Beacon Fen Energy Park – Development Consent Order

Application Reference: **EN010151**

Document: Deadline 8 – Closing Summary Statement (LCJM)

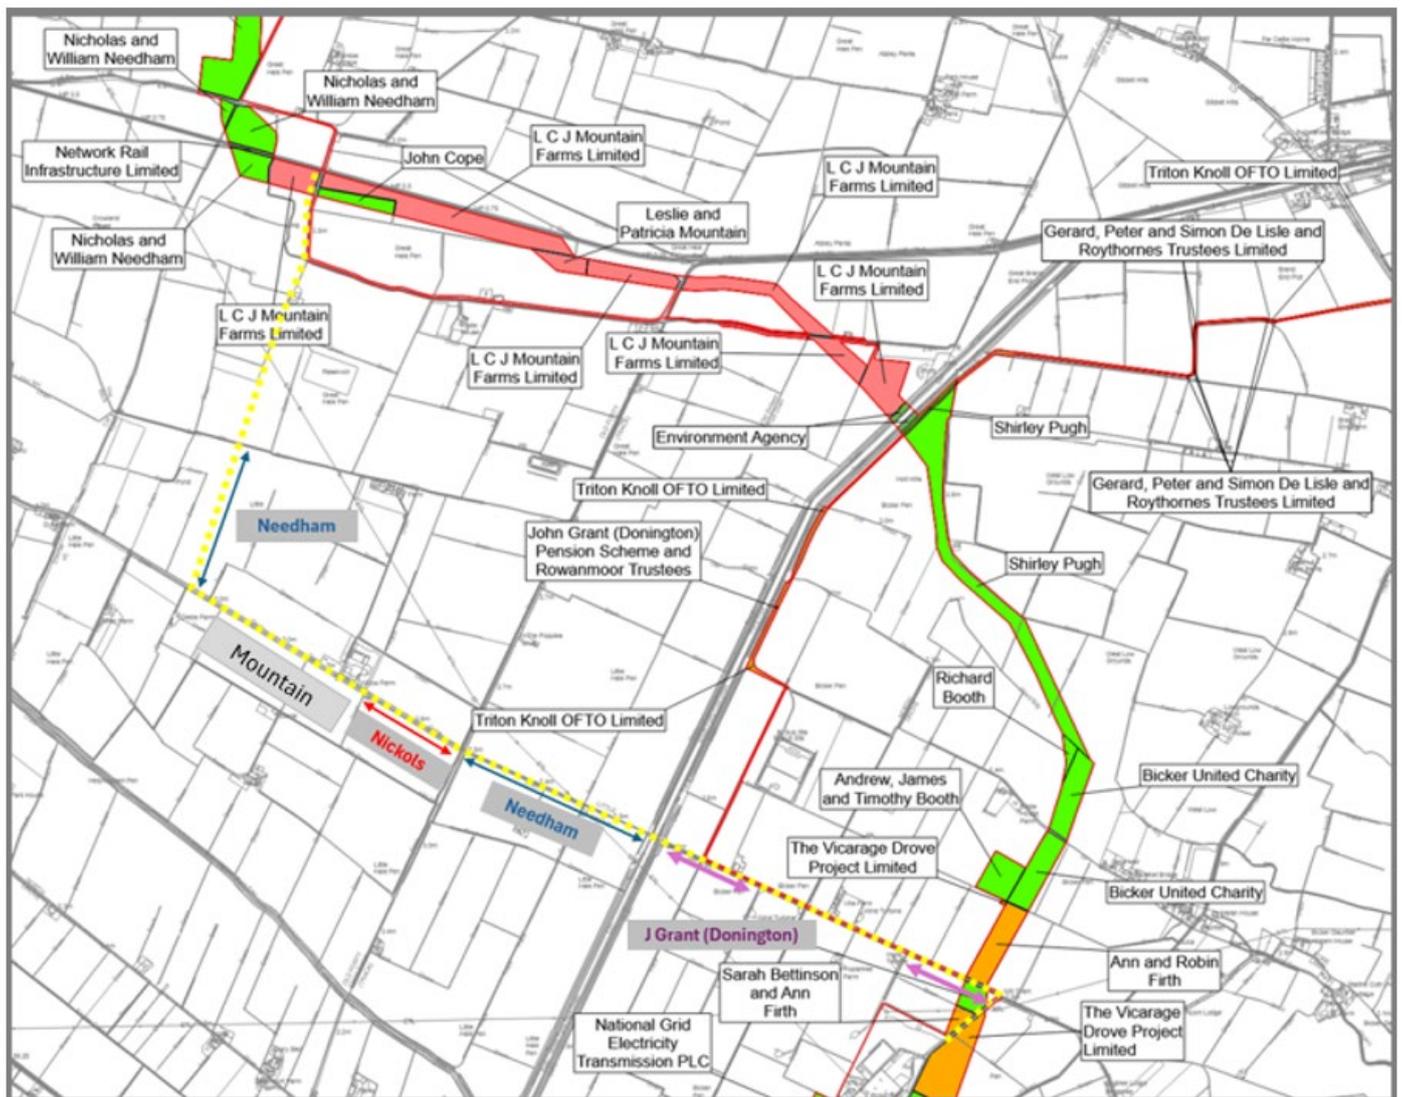
The LCJM Hybrid is introducing [REDACTED] and [REDACTED] west of the South Forty Foot and the land east of the South Forty Foot between [REDACTED] (Donington) - who is affected by both routes - which are

- **LL395174** [REDACTED]
- **LL241762** [REDACTED] *who is affected by both routes*

Therefore, a maximum 3 **NEW** affected landowners (Needham, Nickols and Slater) and relieving 10 landowners from the Beacon Fen cable route; namely –

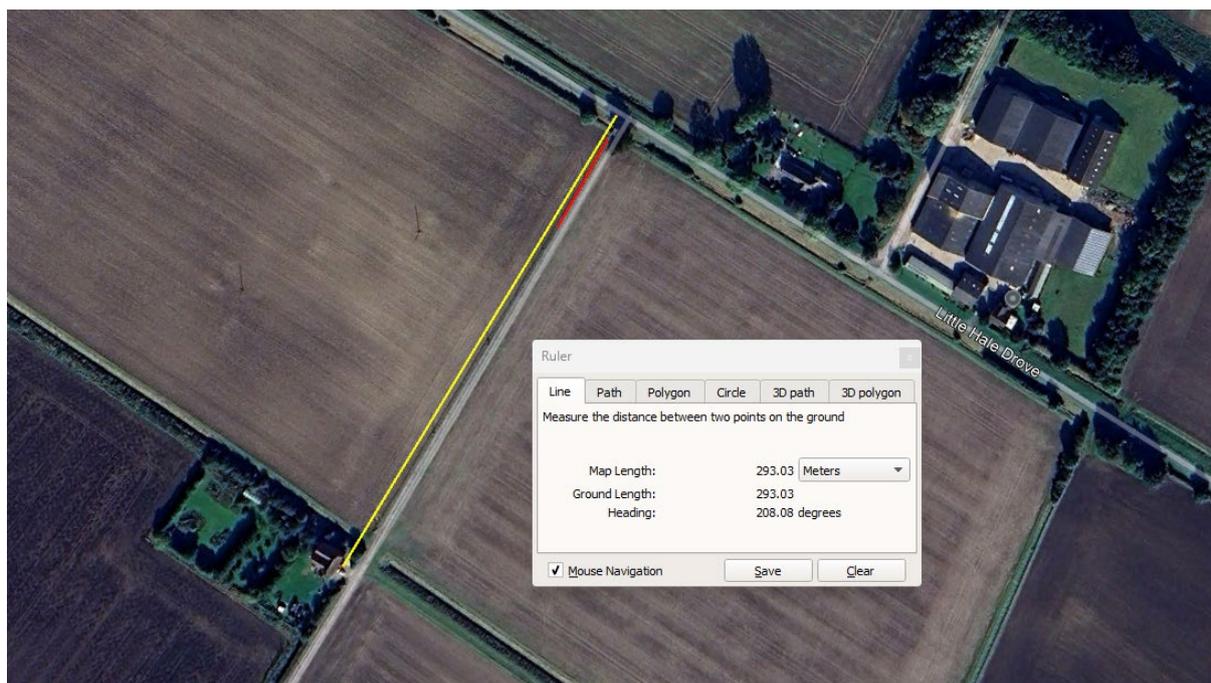
A.9.1 Row 9 is framed as “Air Quality <250m including construction access”, but the Applicant’s comparison is still a corridor-geometry proximity screen, not a like-for-like assessment of construction air-quality risk. The Applicant measures 250m from the *outer edge* of an indicative corridor, while treating haul routes, construction access, compounds and traffic management in narrative rather than as a single mapped construction footprint applied consistently to both routes. The consequence is outcome-determinative: the headline receptor count is driven by corridor-edge assumptions and measurement rules, not by a transparent comparison of the construction logistics package that drives dust/air-quality effects in practice.

A.9.2 The Applicant’s “273m” critique illustrates the defect. The dwelling in Little Hale Fen (NG34 9BG) is c.293m from Little Hale Drove (i.e. the construction access), and >273m from a plausible LCJM Hybrid cable position if micro-sited towards the field edge (as would be typical good practice).

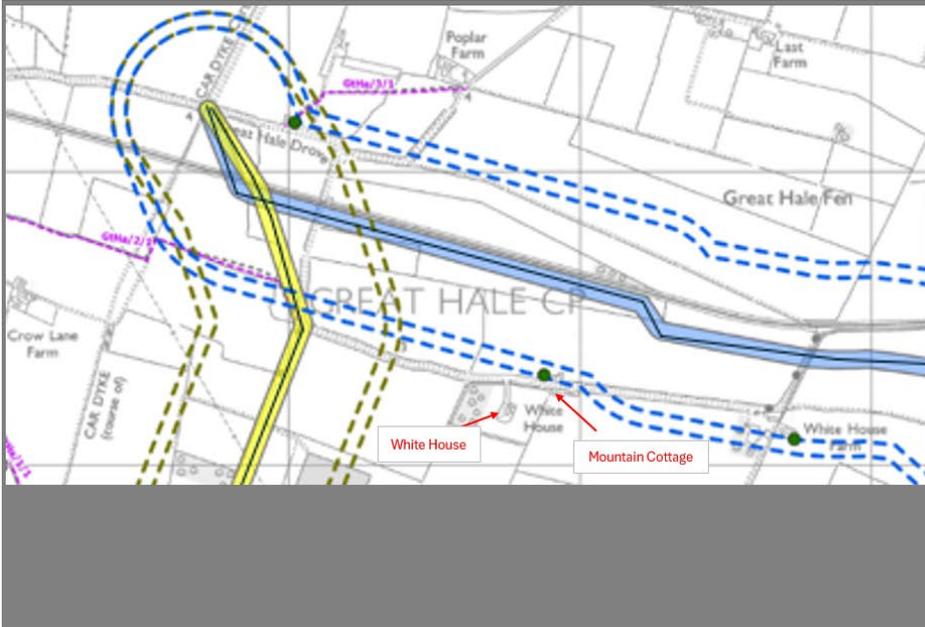
A.9.4 Cumulative context reinforces that caution: receptors potentially affected by construction access/haul arrangements in this locality have experienced relatively recent cumulative construction disturbance associated with the Viking Link onshore works. Corridor-only screens should not be over-weighted where real-world effects are driven by construction logistics, duration and traffic management.

A.9.5 LCJM maintains that, when construction access is treated on a like-for-like basis, the Applicant’s Option 1 corridor affects 7 residential receptors (including **The White House and Mastins Cottage**), as shown below.

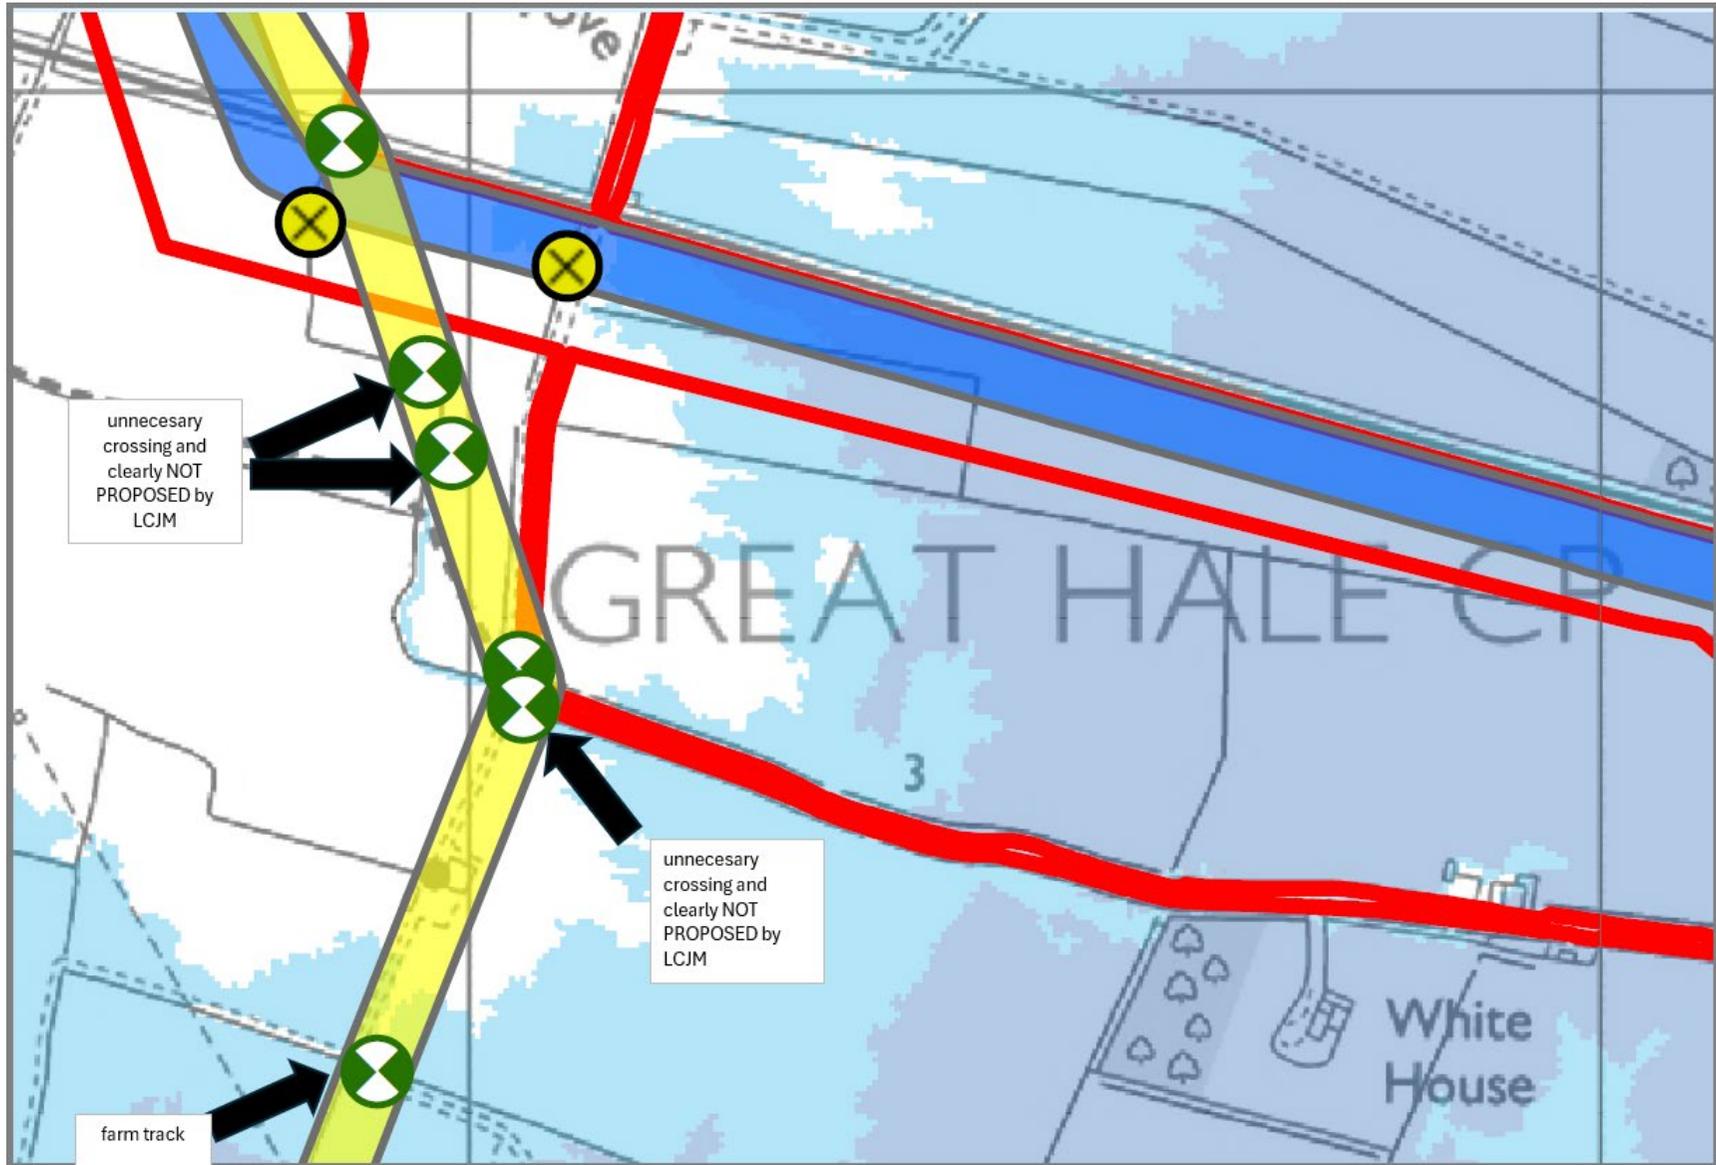
A.10.1 LCJM is concerned that the Applicant’s methodology risks creating an artificially adverse impression of the LCJM Hybrid’s “watercourse interfaces” while presenting the Applicant’s corridor more favourably, without a transparent, like-for-like rule. Row 10 is presented as a simple “crossing count”, but the Applicant has not provided a decision-safe definition of “crossing” (what is counted/excluded and why). LCJM does not accept that the Applicant’s counts for the LCJM Amended Alternative are correct.

A.10.2 Micro-siting sensitivity. As shown on LCJM’s marked-up figures (black arrows below), the Applicant’s plotted LCJM Hybrid alignment introduces avoidable interfaces (including avoidable additional crossings and the Great Hale Drove interface).

A minor re-alignment through the narrowest feasible point within LCJM’s field – as shown by the yellow dotted line in the diagram above – can reduce interfaces materially without affecting deliverability. This illustrates why headline “crossing counts” are not decision-safe discriminators if the plotted line is treated as fixed.

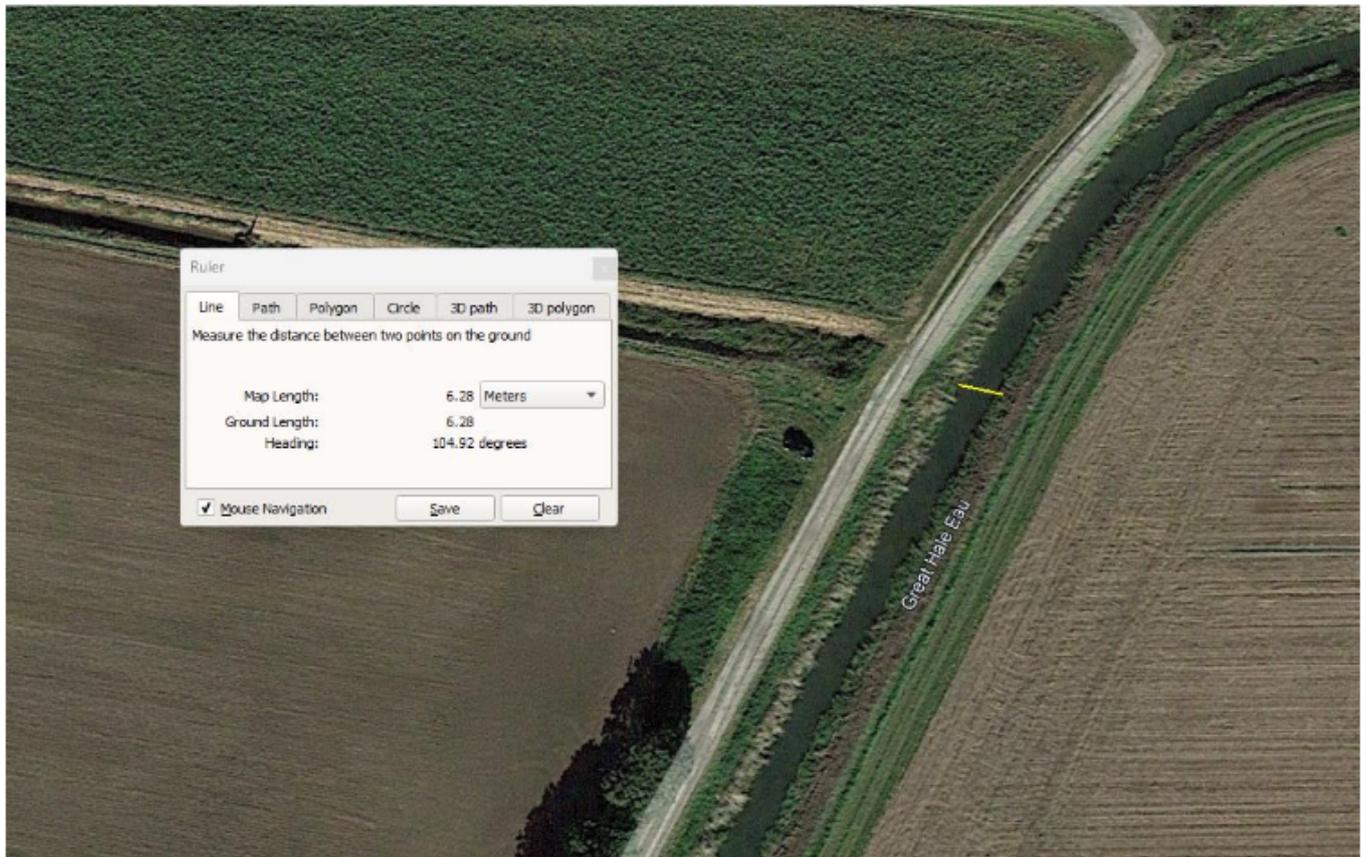
A.10.5 Applicant under-count on LCJM land. LCJM also maintains that the Applicant has missed (and continues to miss) watercourse crossings on the Applicant's own corridor on LCJM's land, as shown on LCJM's marked-up figures (black arrows). On LCJM's review, this results in **17** crossings for the Applicant's Option 1 corridor. The Applicant has not provided an auditable mapping output identifying which features it counted/excluded and why.

This makes 17 crossings for the Option 1 route and 15 for the LCJM Hybrid route.

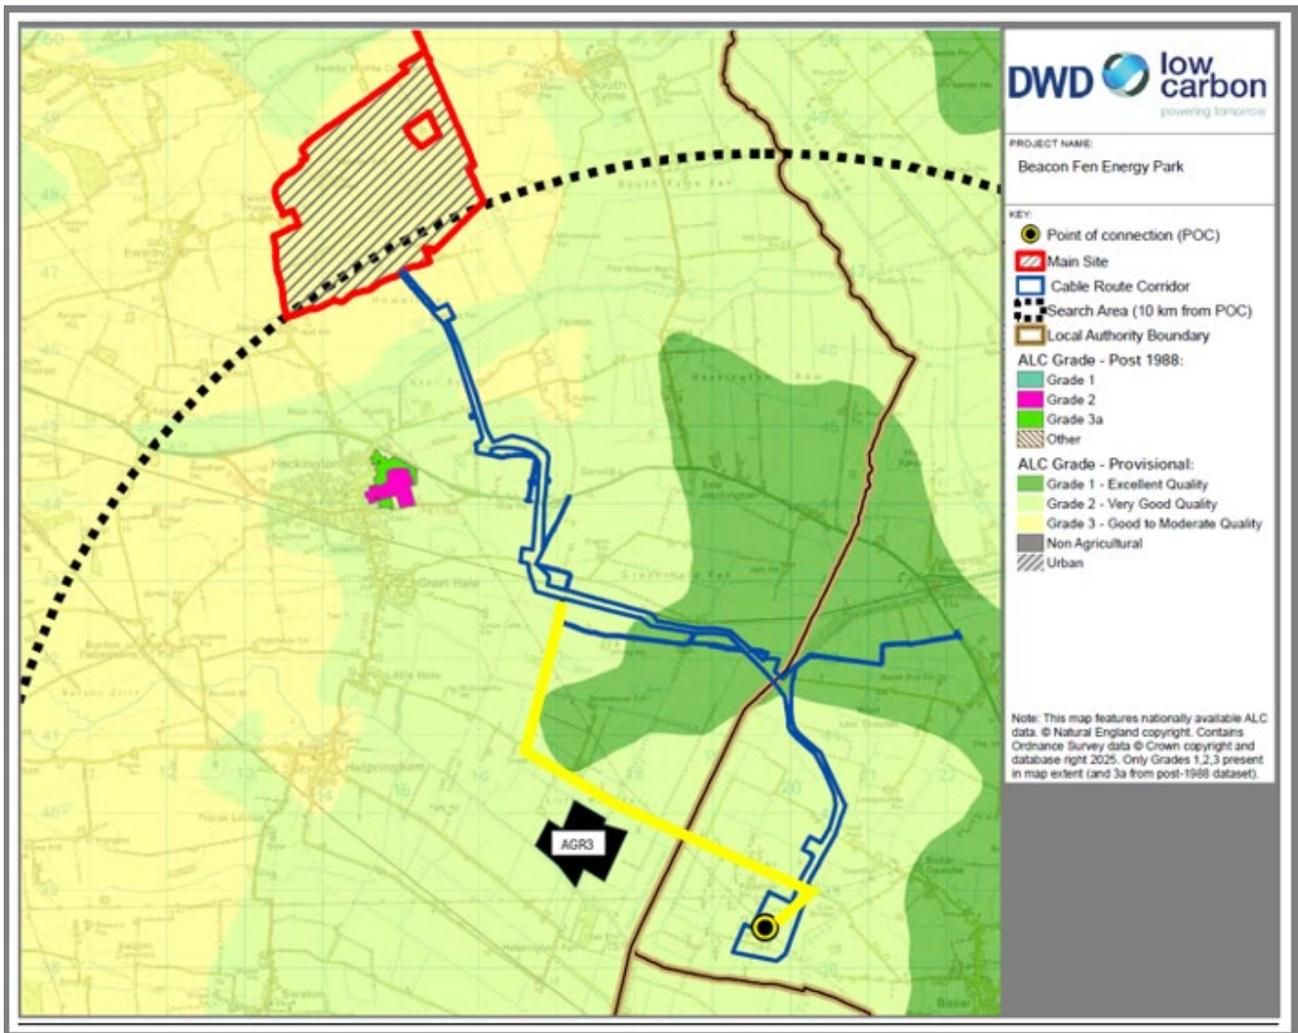
A.11.5.a Contemporaneous land-manager evidence / engagement context. LCJM also relies on its Aug-23 engagement correspondence (**ExD8.1–ExD8.2**) as contemporaneous evidence that the Applicant was expressly informed that the key Little Hale Fen land block being offered/picked-up was understood and presented by LCJM as **predominantly Grade 3**. That evidence is not advanced as a substitute for route-specific ALC survey, but it is relevant corroboration that (i) LCJM put land capability/grade in issue during optioneering, and (ii) proportionate ground-truthing with the land manager (crop/rotation and irrigation capability evidence) was readily available but not taken up.
